Docket Number:	06-AFC-07C
Project Title:	Humboldt Bay Generating Station - Compliance
TN #:	204528
Document Title:	Site Boundary Expansion & Project Modification
Description:	Petition to Amend to expand the site boundary
Filer:	John Carrier
Organization:	CH2M HILL
Submitter Role:	Applicant Consultant
Submission Date:	5/7/2015 12:05:49 PM
Docketed Date:	5/7/2015

Subject: Humboldt Bay Generating Station - Petition for Project Modification (06-AFC-07C)

Site Boundary Expansion and Project Modification

FIGURE 2-2
HBGS Expanded Site Boundary
and Project Modification Features
Humboldt Bay Generating Station
Eureka, California

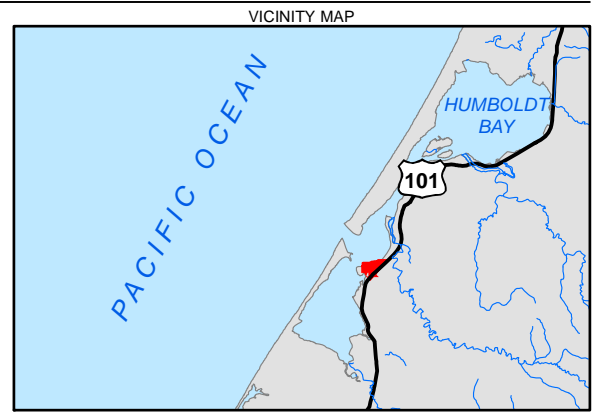
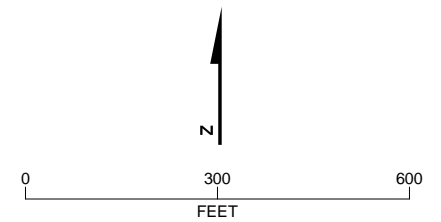
Both the construction and operations-related modifications are discussed in Section 2.1.3. Figure 2-2 depicts the expanded HBGS site boundary and project modification features included in this Petition.

In addition, three buildings within the expanded HBGS site boundary will remain after decommissioning and restoration, and these buildings will be used by ISFSI personnel for office space (Figure 2-2). The buildings will be secured with key card access only available to ISFSI personnel. A pedestrian gate will be installed to provide ISFSI personnel access to the buildings.
